# HISTORIC AND DESIGN REVIEW COMMISSION

**HDRC CASE NO:** 2022-345  
**ADDRESS:** 305 LAVACA ST  
**LEGAL DESCRIPTION:** NCB 708 BLK 8 LOT 2  
**ZONING:** RM-4, H  
**CITY COUNCIL DIST.:** 1  
**DISTRICT:** Lavaca Historic District  
**APPLICANT:** Caroline Gado  
**OWNER:** Leslie Jones/1918 MLK DEVELOPMENT GROUP LLC  
**TYPE OF WORK:** New construction of two, 2-story duplex structures  
**APPLICATION RECEIVED:** September 28, 2022  
**60-DAY REVIEW:** Not applicable due to City Council Emergency Orders  
**CASE MANAGER:** Rachel Rettaliata

The applicant is requesting conceptual approval to construct two, 2-story duplex structures at 305 Lavaca.

③ REAR ELEVATION- NORTH  
SCALE: 1/4" = 1'-0"

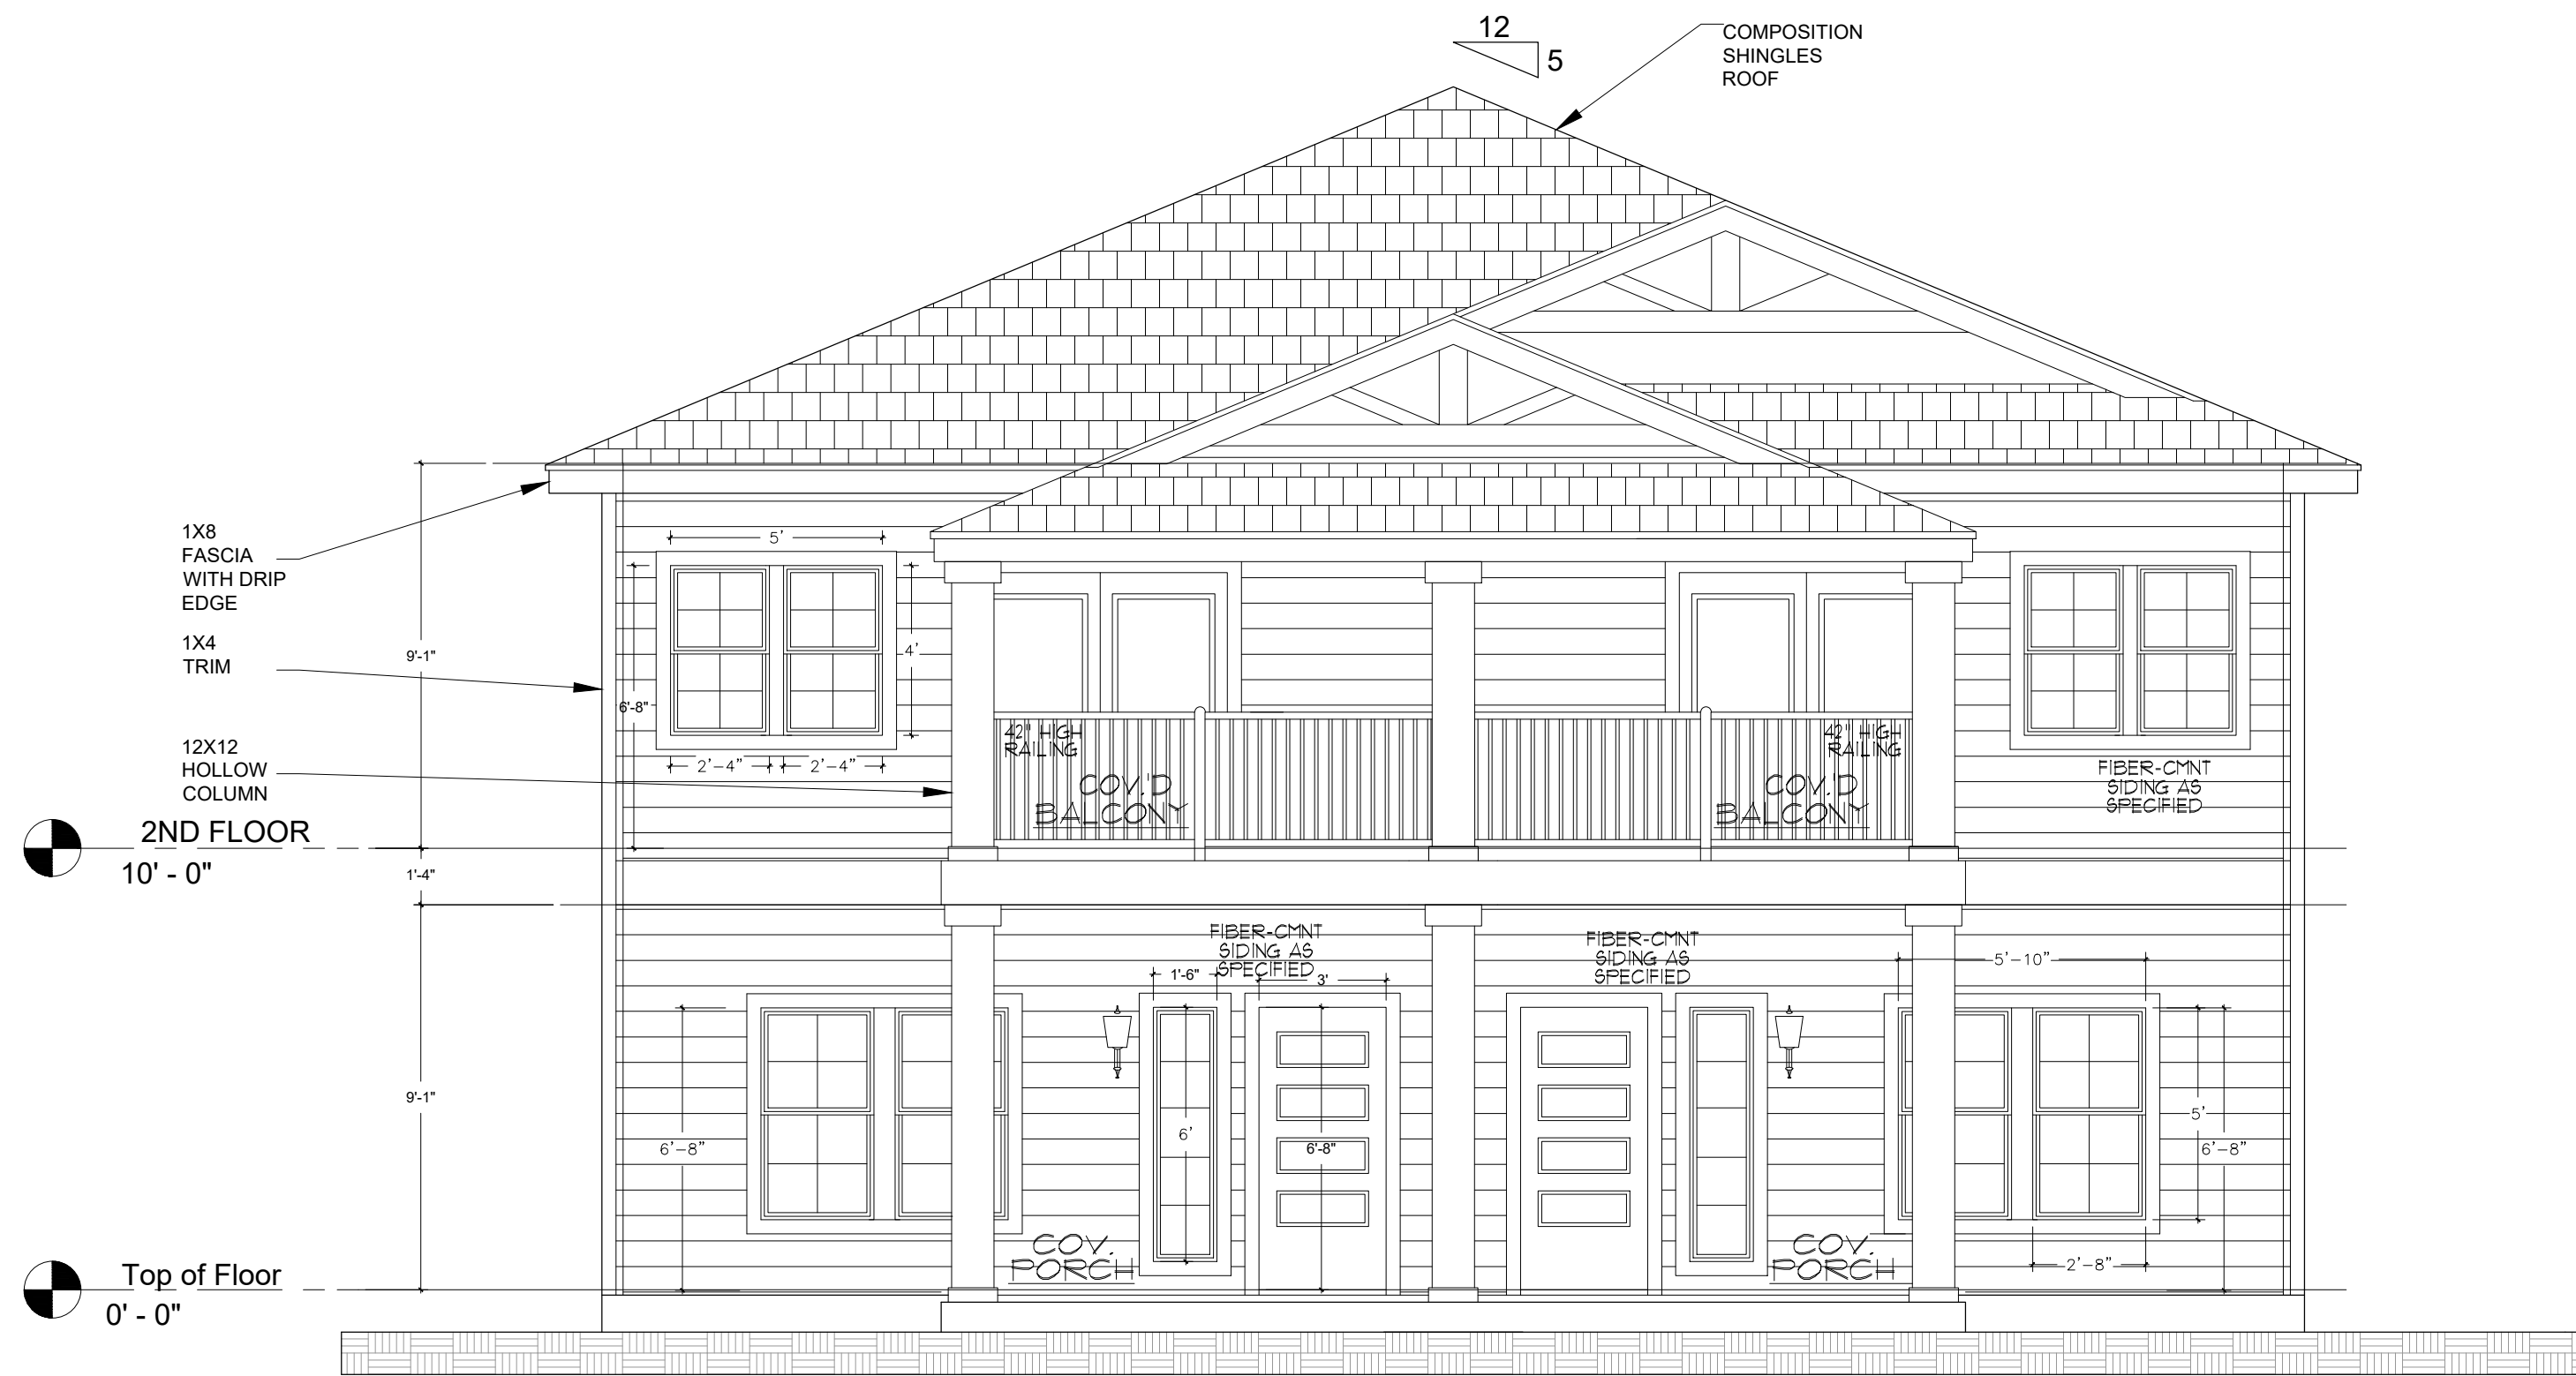
- g. **SCALE & MASSING** – According to Guideline 2.A.i for New Construction, new structures should feature a height and massing that is similar to historic structures in the vicinity. In residential districts, the height and scale of new construction should not exceed that of the majority of historic buildings by more than one story. The blocks of Lavaca and Garfield Alley feature one-story and two-story historic structures. Guideline 2.A.ii for New Construction states that applicants should utilize step-downs in building height, wall-plane offsets, and other variations in building massing to provide a visual transition when the height of new construction exceeds that of adjacent historic buildings by more than one-half story. Staff finds that the applicant should reduce the overall massing.

- i. **ROOF FORM** – The applicant has proposed a pyramidal roof form with double front gables on each of the duplexes. According to Guideline 2.B.i for New Construction, new construction should feature roof forms that are consistent with those predominantly found on the block. The blocks of Lavaca and Garfield Alley feature structures with front gable roofs, cross gable roofs, side gable roofs, hip roofs, and shed roofs. Staff finds the proposal consistent with the Guidelines.

- m. **RELATIONSHIP OF SOLIDS TO VOIDS** – The applicant has proposed to install divided lite one-over-one windows on the duplex structures. The proposed fenestration pattern consists of sets of 2 ganged windows on the front facades, single, ganged, and small fixed windows on the side elevations, and single windows on the rear elevation. The proposed window proportions vary in size and all of the proposed windows do not appear to be in keeping with those historically found in the district. Guideline 2.C.i for New Construction states that window and door openings should be incorporated into new construction with a similar proportion of wall to window space as typical with nearby historic facades. Windows, doors, porches, entryways, dormers, bays, and pediments shall be considered similar if they are no larger than 25% in size and vary no more than 10% in height-to-width ratio from adjacent historic facades. Staff finds that the proposed fenestration should be updated to be more in keeping with the Guidelines.

- o. FRONT PORCH – The applicant has proposed to construct a double-height front porch on each of the duplex structures. The proposed front porches feature square columns, a second-floor porch handrailing, and decorative gable detailing. Staff finds that the proposed columns should be a maximum of 6”x6” in width and feature a traditional cap and base and chamfered corners and that the applicant submits details for the proposed columns and railing.

LG: As far as massing and window and roof shape, this seems to comply looking at the elevations. There is an unusual window orientation, looking at the rear elevation.

LG: I have a design question related to the front elevation and the brick base on the columns. The brick base is something that you may see on a Craftsman home and the columns are more Neo-Classical in style.

RM: The central wall has a strange appearance.

LG: Having two columns in place of the divider wall may be more in keeping with the predominant style of the neighborhood.

RM: I think the brick would work best as a free-standing column as opposed to a column on a brick base.

- ii. That the applicant reduces the massing and provides a diagram showing the height of the proposed structures in relation to neighboring structures, including proposed foundation and floor heights based on finding g and h.

- iv. That the applicant proposes window sizes, patterns, proportions, and trim and sill detailing that are consistent with the Guidelines and historic precedents in the district as noted in finding m.

- v. That the applicant submits details for the proposed porch columns and railing based on finding o. The proposed columns should be a maximum of 6”x6” in width and feature a traditional cap and base and chamfered corners.
